RE: 186 Grove St, Site Plan Review – Peer Review Comments

**Re: 186 Grove Street  
Site Plan Peer Review**

BETA Group, Inc. has reviewed revised documents for the proposed Site Plan Application, "Proposed Site Improvements – 186 Grove Street, Franklin, MA." This letter is provided to update findings, comments, and recommendations.

**RE: Site Plan Modification Review – 186 Grove St**

5 BRICK COURSE MAXIMUM

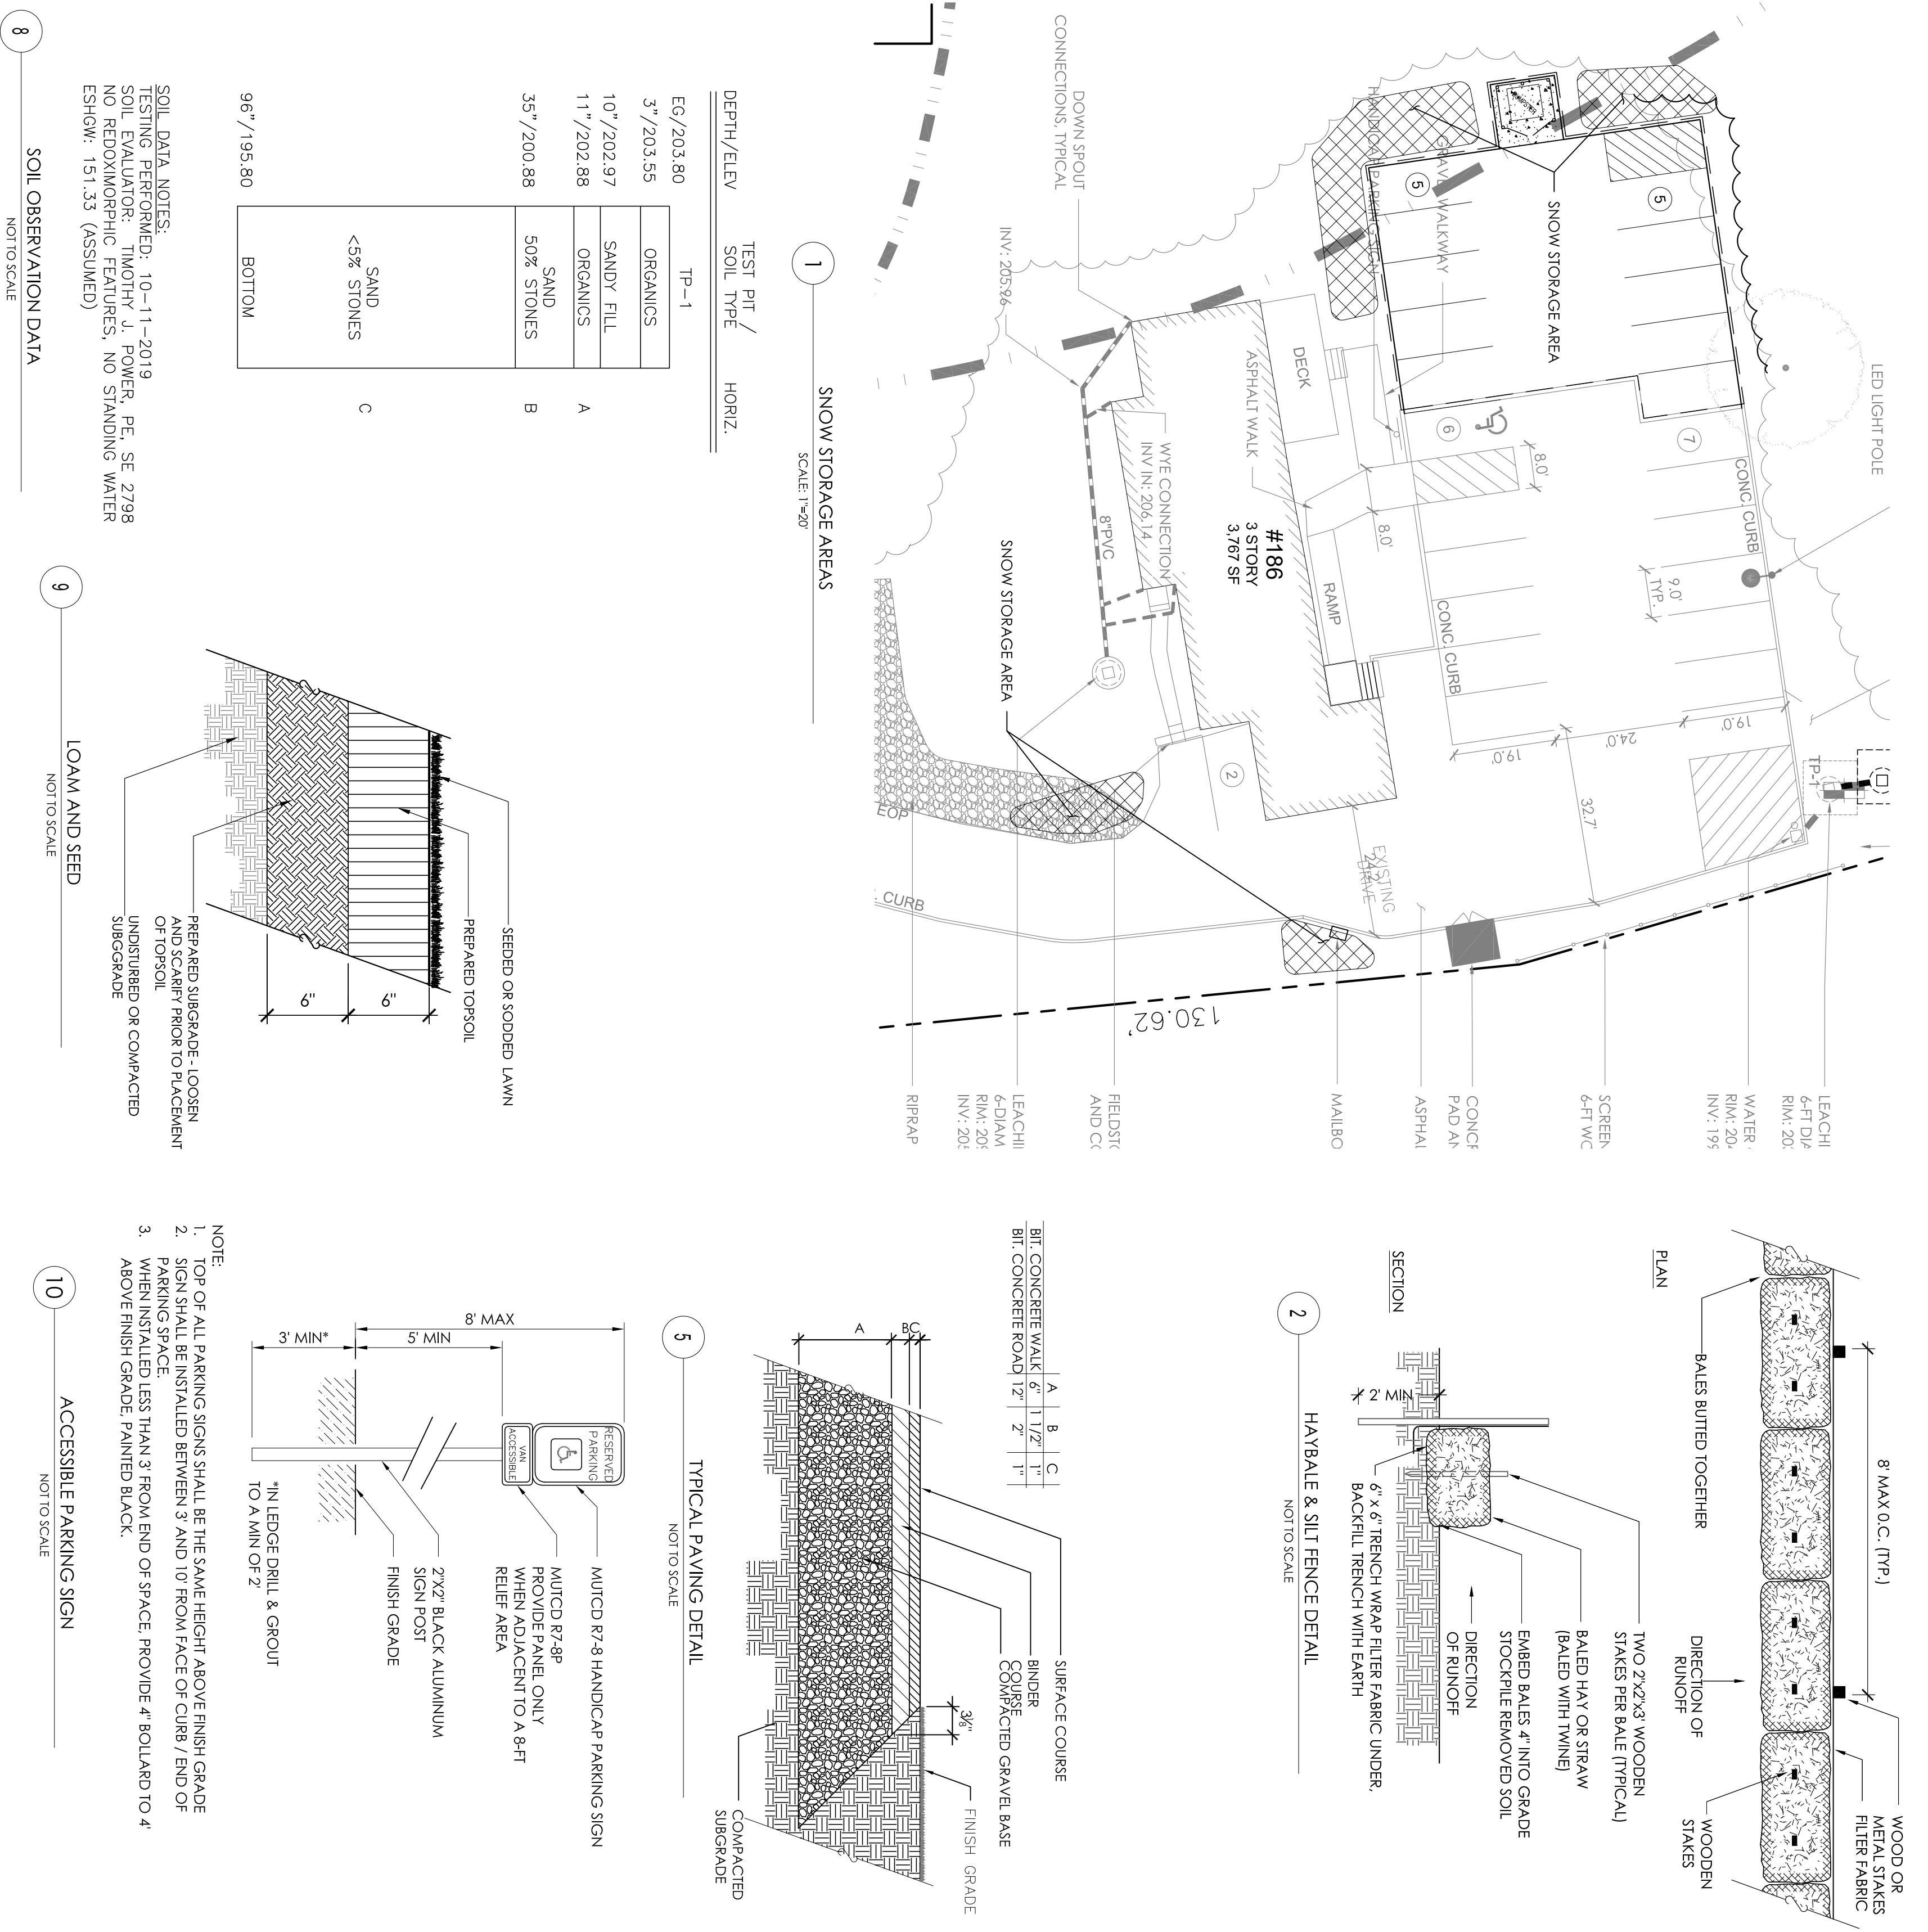
SW1. Clarify if a pipe connection (recommended) is proposed between the two leaching basins.

- SW1. Clarify if a pipe connection (recommended) is proposed between the two leaching basins. *PVI: The plans have been revised to proposed a pipe between the two leaching structures.* **BETA2: At the discretion of the Board revise the proposed PVC pipe to RCP. BETA notes the proposed pipe is located outside of any areas subject to traffic loading.**

***The plans have been revised to propose a pipe between the two leaching structures.***
